Project Name: Castillo Residence

Street Address: 46 Buchanan St Pearl River

DENIAL TO THE ZONING BOARD OF APPEALS

Date: July 7, 2022
Applicant: Castillo
Address: 46 Buchanan, Pearl River, NY
RE: Application Made at: same

Land Survey
For
"CASTILLO"

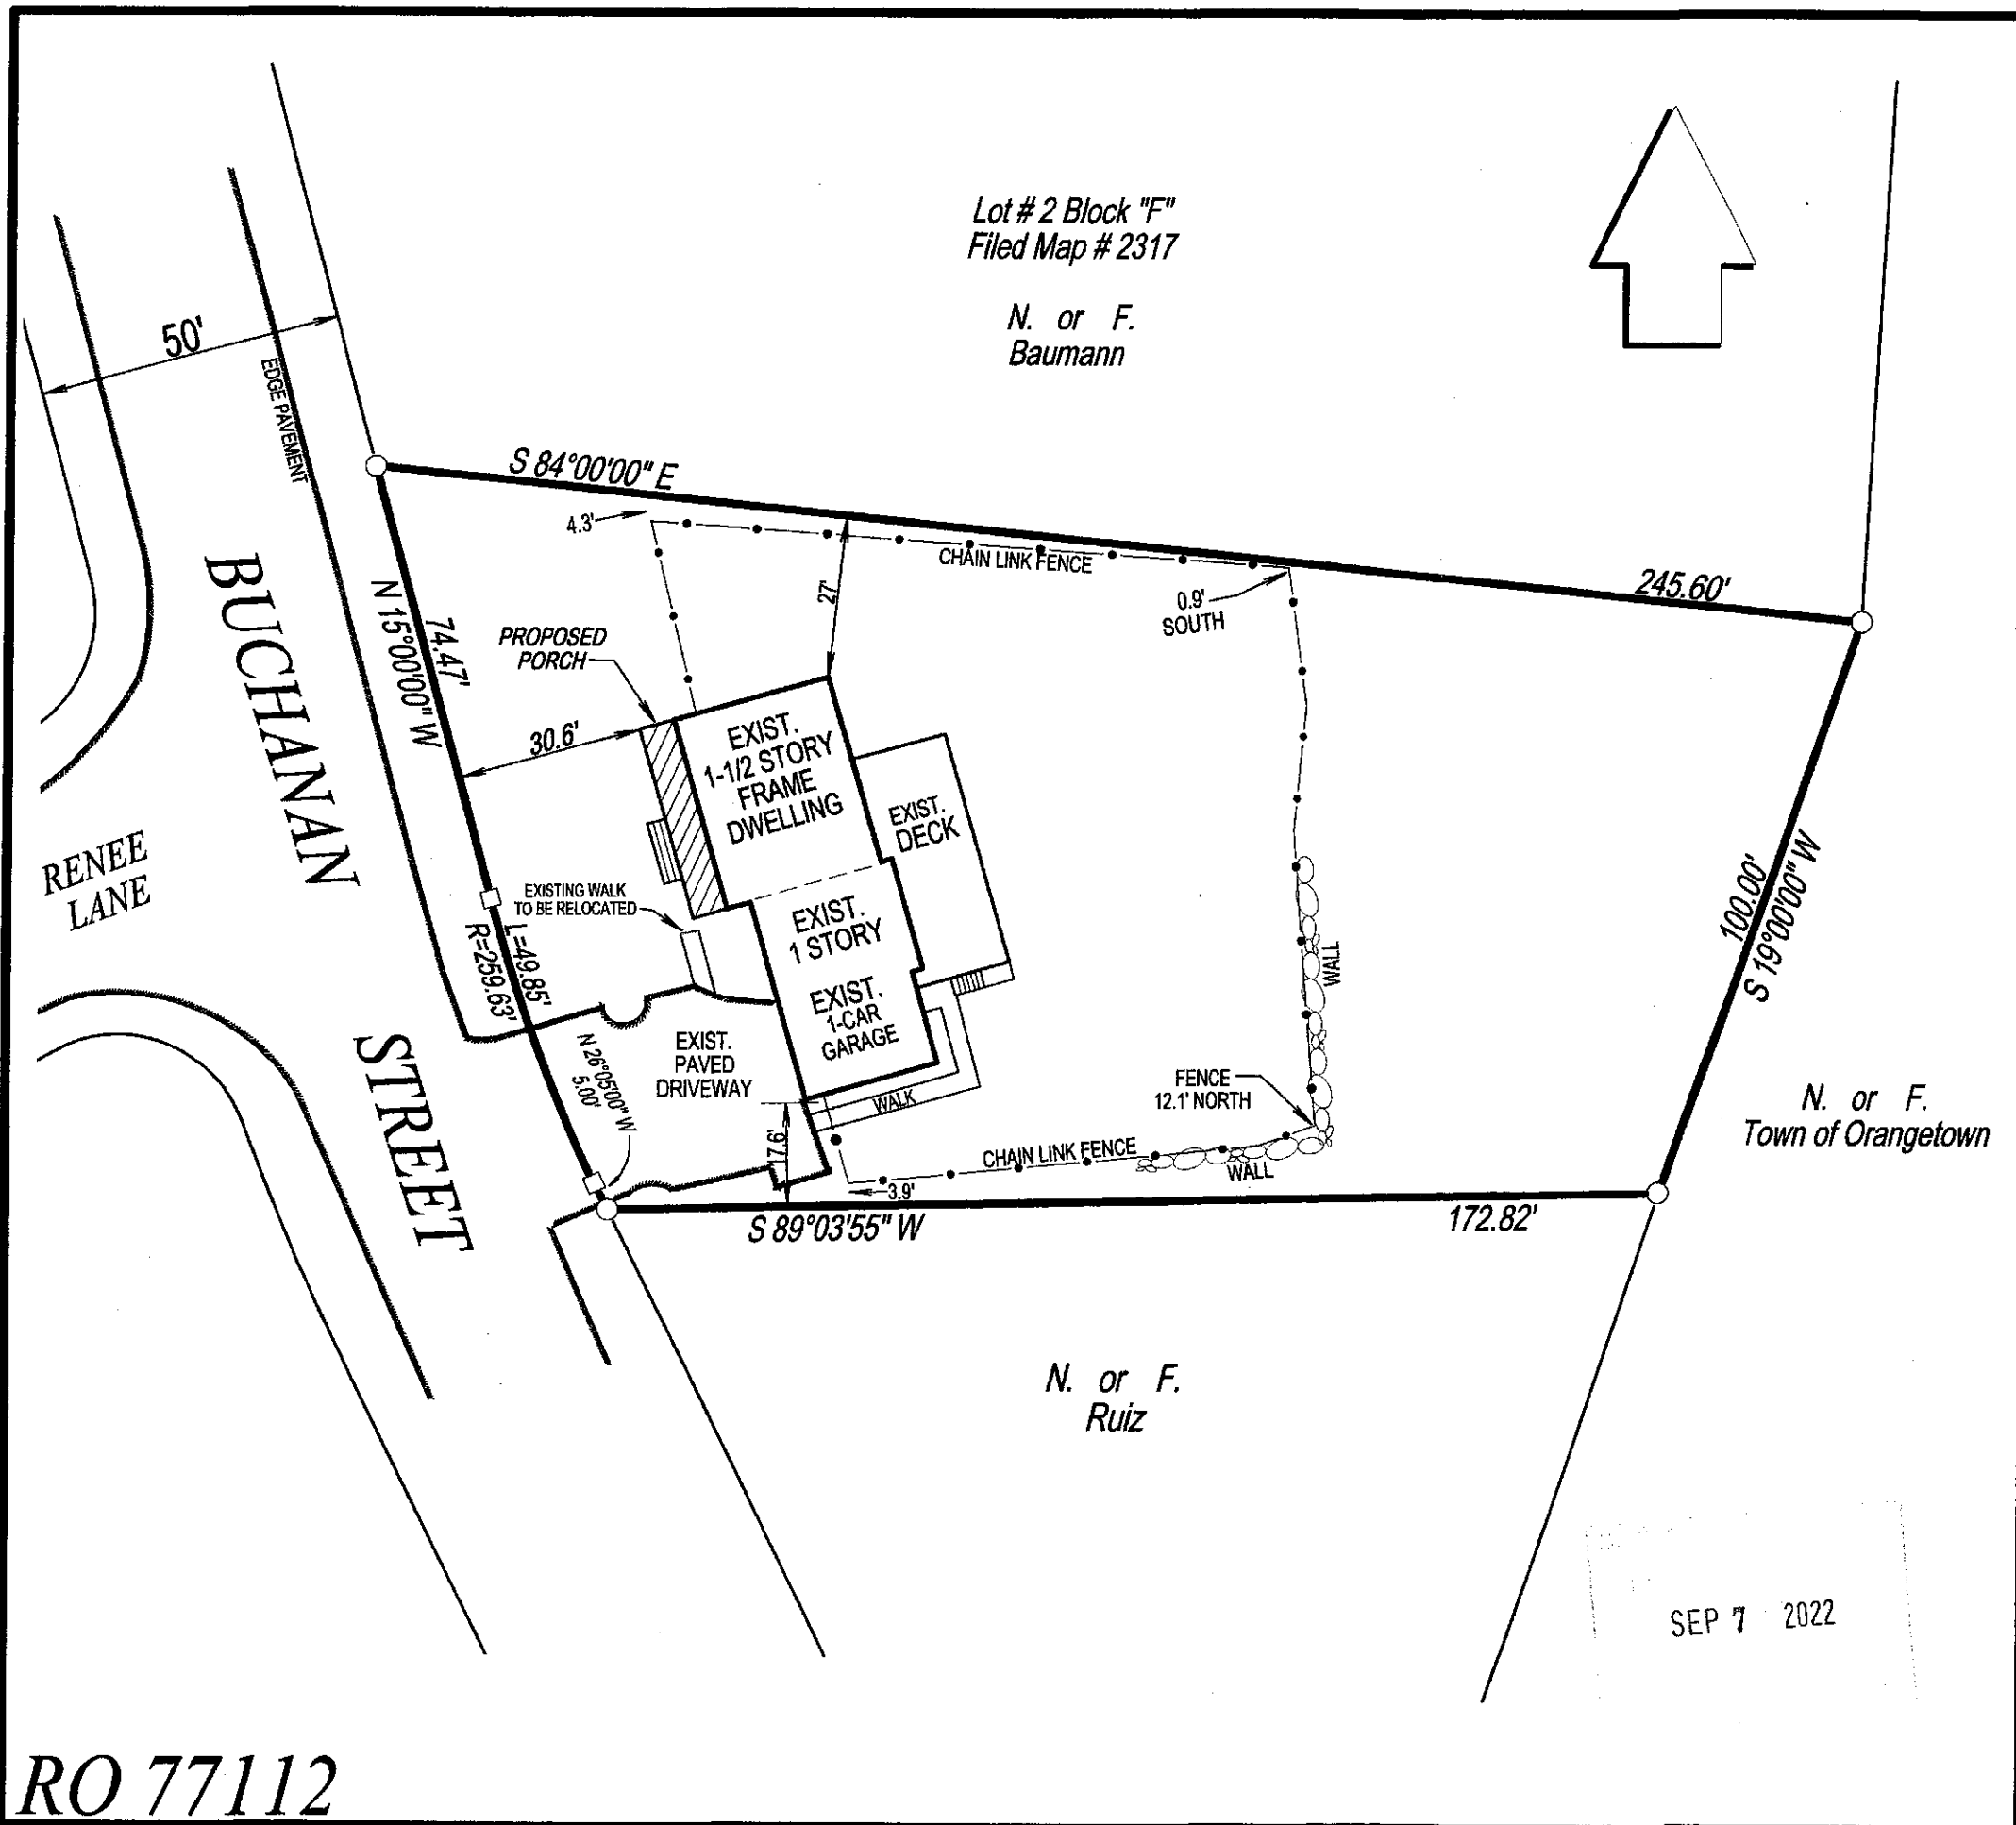
Chapter 43, Table 3.12, Column 1 R-15 District, Column 2 Group M, Column 3 SFR, Column 10 Total Side Yrd 50' w/ 44.5' proposed
Chapter 43, Section 9.34 Extension or Enlargement except as follows: to the extent the district bulk regulations permit, and on application to the Board of Appeals
One variances required

***ORIGINAL SURVEY SUBMITTED INACCURATELY RESULTING IN APPLICATION
NEEDING TO BE RECALLED AND REFERRED TO ZBA

** SUBMIT BOTH COPIES
OF ATTACHED SURVEYS
TO ZBA*
